The following is to be read and form part of the contract documents for the above project.

RESPONSES TO QUESTIONS DURING TENDERING

END OF ADDENDUM NO. 3

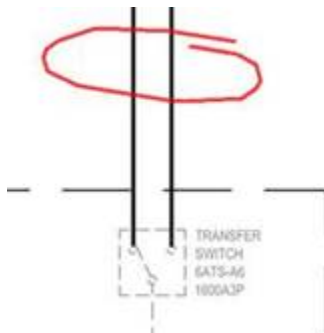
1. REFER TO DRAWING E7-01-04: What size of cables are to be pulled from existing transfer switch '6ATS-A6' located on A-6 Pumphouse?

Response: Conductors not in contract, to be completed by others in separate work.

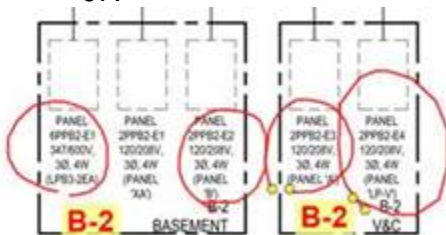
2. Please confirm the location of the following encircled panels shown on drawing E7-02-07.

Response: 1. PANEL 6PPB2-E1(LP3-2EA) SPECIFIED IN DWG. E6-02-01 "CONTRACTOR TO COORDINATE WITH OWNER TO VERIFY LOCATION ON SITE".
 2. PANEL 2PPB2-E2(PANEL B) TO ISSUE AN ADDENDUM IN DWG. E6-02- 01 "CONTRACTOR TO COORDINATE WITH OWNER TO VERIFY LOCATION ON SITE"
 3. PANEL 2PPB2-E3(PANEL A) REFER TO DWG. E2-02-02 DETAIL 2. TO ISSUE ADDENDUM PANEL NAME 2PPB2-E3 IN LIEU OF 2PPB2-E2
 4. PANEL 2PPB2-E4(LP-V) REFER TO DWG E2-02-02 DETAIL 2

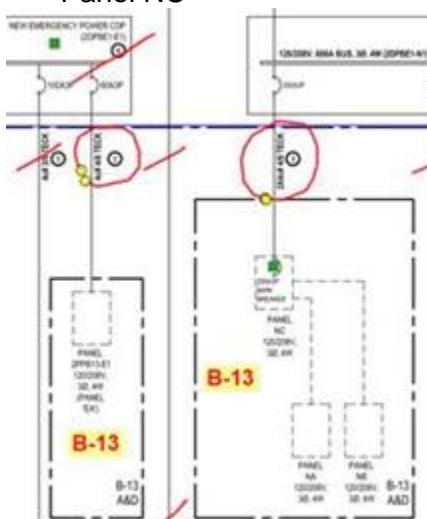
3. Please confirm routing of the encircled cables for these two panels – '2PPB13-E1' and 'Panel NC'

Response: From BE-1 to B12 via duct bank, B-12 to B-13 through tunnel and B-2.

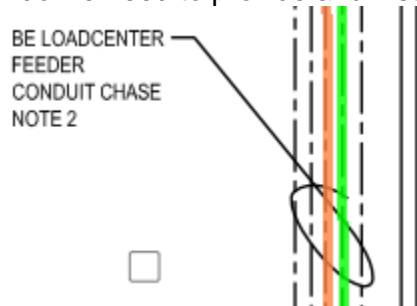
4. Please clarify what Note 2 is as shown on E2-02-04, Detail 1? Is there an existing chase or do we need to provide and install a cable tray?

Response: No existing chase. Provide and install cable tray or conduit suspended from structure to suit installation.

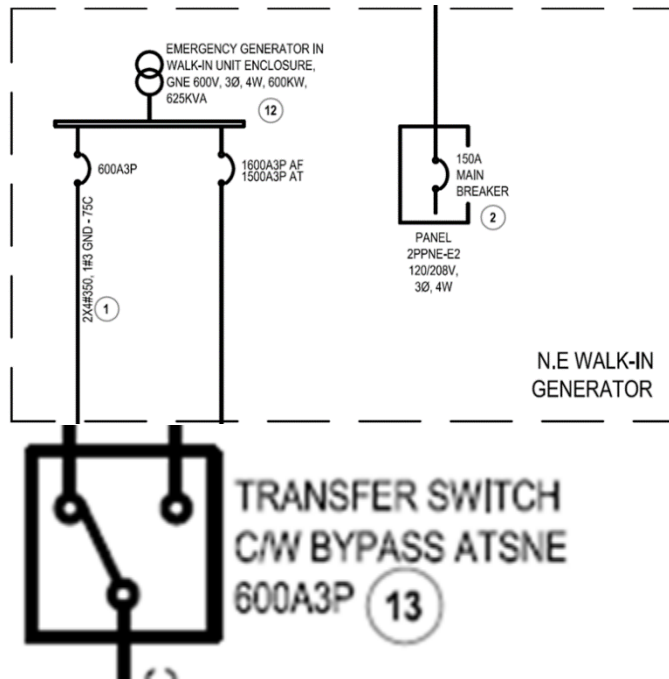
5. The location of the this duct bank on drawing E1-05-01 doesn't coincide with the location on drawing E1-02-01. Please clarify.
Are we going to use a pull pit or a manhole? Please clarify.

Response: Install manhole (per WP02) in location identified in WP04.
